**Changes for revision Ga to revision Gb (10/14/79 by CT). Fixes interval timer inaccuracy.**

XEROX PARC/C.S.	Project DO	Title DO MISC board Changes	File DOMISCChanges	Designer CPT	Rev Gc	Date 7/17/80
--------------------	---------------	--------------------------------	-----------------------	-----------------	-----------	-----------------

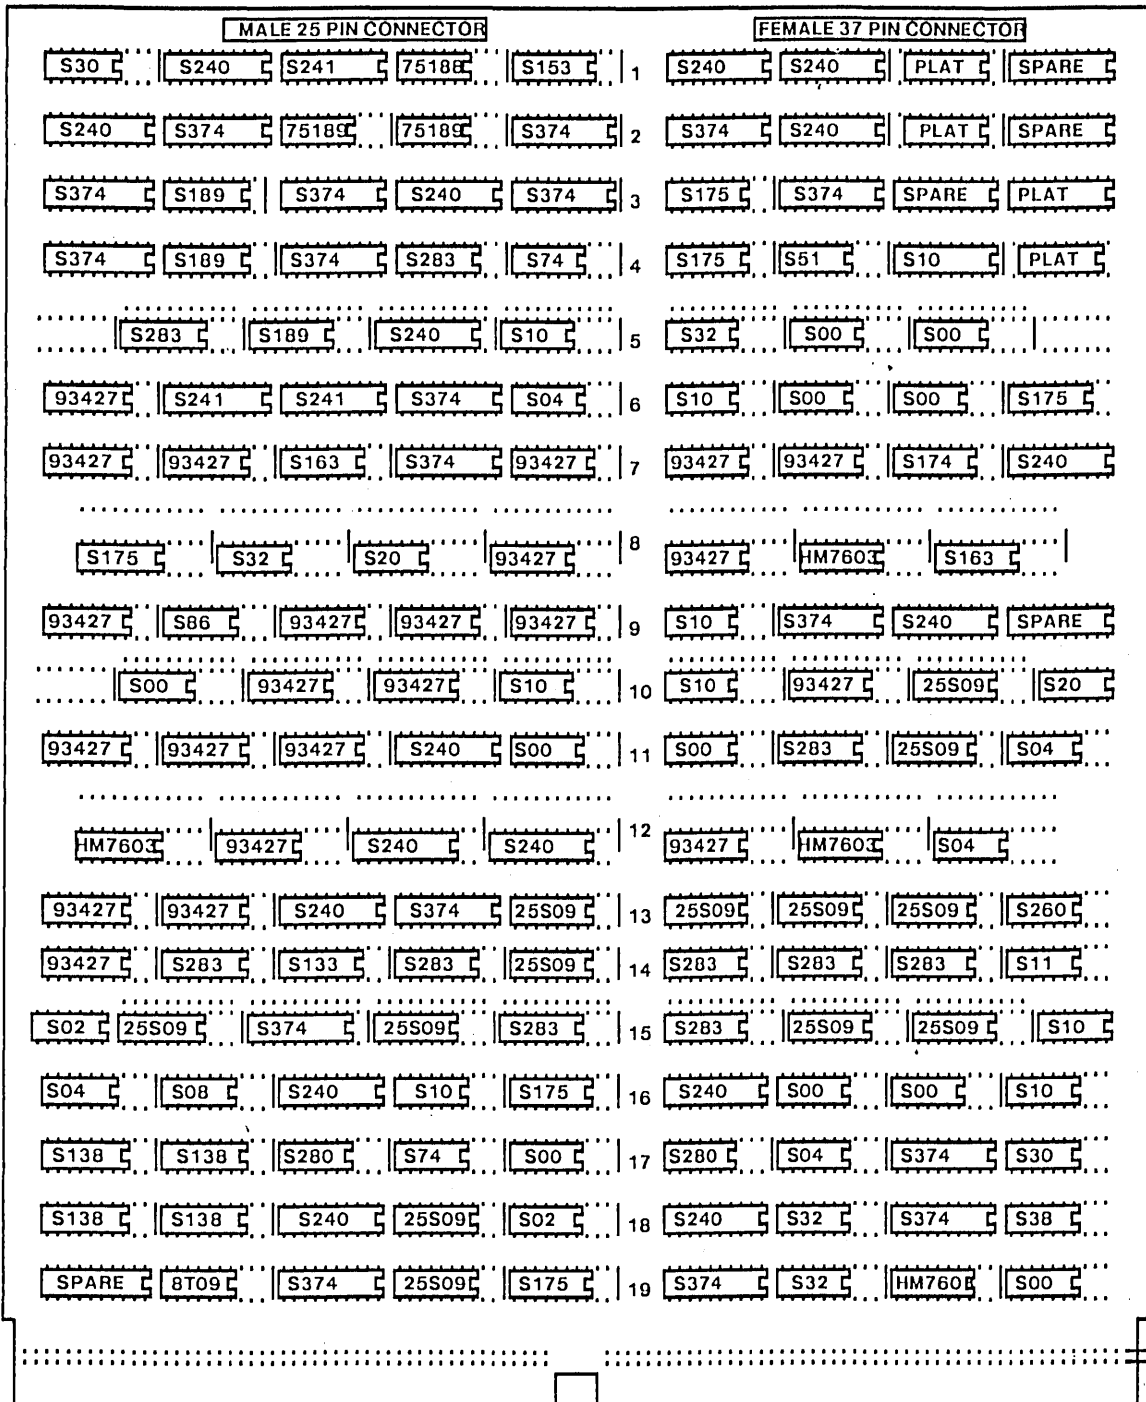
Note: This change comes in two flavors: Revision Ga multiwire boards have 2 extra IC's mounted in spare positions b3 (93427) and b4 (74S10). In the Multiwire Gb version, the S10 is in position b4, but the 93427 replaces the S85 in position i9. The logic diagrams show the revision Gb multiwire version of the change. To modify a revision Ga multiwire board, proceed as follows:

In the steps below, pin numbers are those of the chips, not those of the 20 pin sockets used to hold the chips. Chip b4 is mounted with pin 7 in pin 10 of the 20 pin pattern, b3 is mounted with pin 8 in pin 10 of the 20 pin pattern.

All wiring is to be done on the back (non-component) side of the board.

- 1) Add an S10 in position b4 and wire b4.14 to pin 20 of the pattern (Vcc).
- 2) Add a 93427 (programmed) in position b3, and wire b3.16 to pin 20 of the pattern (Vcc).
- 3) Lift pins b5.1, b5.2, and b5.3.
- 4) Remove chip i9 and jumper i9.6 to i9.8
- 5) Add b5.1 to b4.1
- 6) add b5.2 to b4.2
- 7) add b5.3 to b4.12
- 8) add b3.14 to b3.13 to b3.8
- 9) add b3.5 to f6.12
- 10) add b3.6 to f6.15
- 11) add b3.7 to f6.16
- 12) add b3.4 to f6.19
- 13) add b3.3 to e2.13
- 14) add b3.2 to e2.14
- 15) add b3.1 to e2.17
- 16) add b3.15 to e2.18

- 17) add b3.9 to b4.13

SPLAT at b1

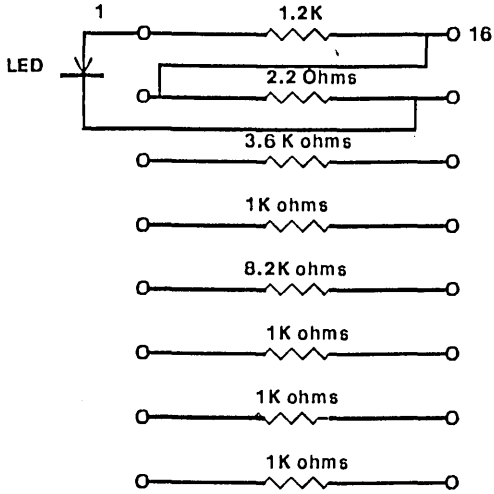
- 1) Changed layout - g1 is S241, not 75188
- 2) Modified platforms b1, a3.
- 3) (pg 1) b17.1 is GND, not PDTf.
- 4) (pg 10) b1.9 is VCC, not GND
- 5) (pg 10) Added S241 driver for PD.O-PD.7. (note - early etch boards will NOT have this change)
- 6) (pg 12) i6.14 is PDTa, not LoadAdd
- 7) (pg 13) i4.1 is PDTf, not GND

FPLAT a3

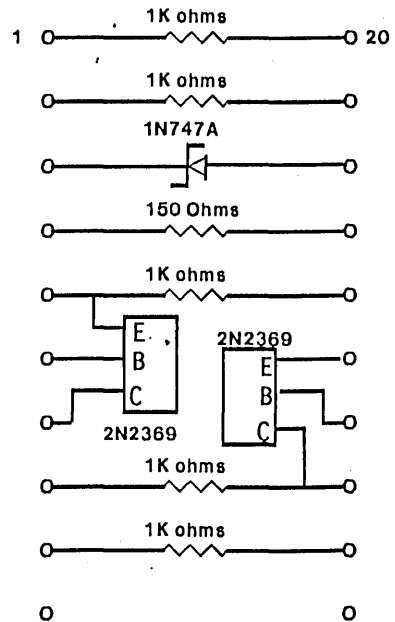
- 1) Reduced number of outbound RS232 lines to 4. Looped RS232 data back on R.14. Added SetTime as bit 11 in the output register (goes to E4B). Added IntPending as bit 10 of the register. All changes on pg 15.
- 2) Terminated PI.O - PI.4. Used R bus drivers PI.5-7 for voltage monitors.
- 3) Added a11e, b6d, b6c, e6f on pg 3 to cause IntPending to dispatch to Opcode0 on interrupt.
- 4) Added test pullups and pulldowns.
- 5) Added +5 monitor at a3 (pg 15) to control RUN.
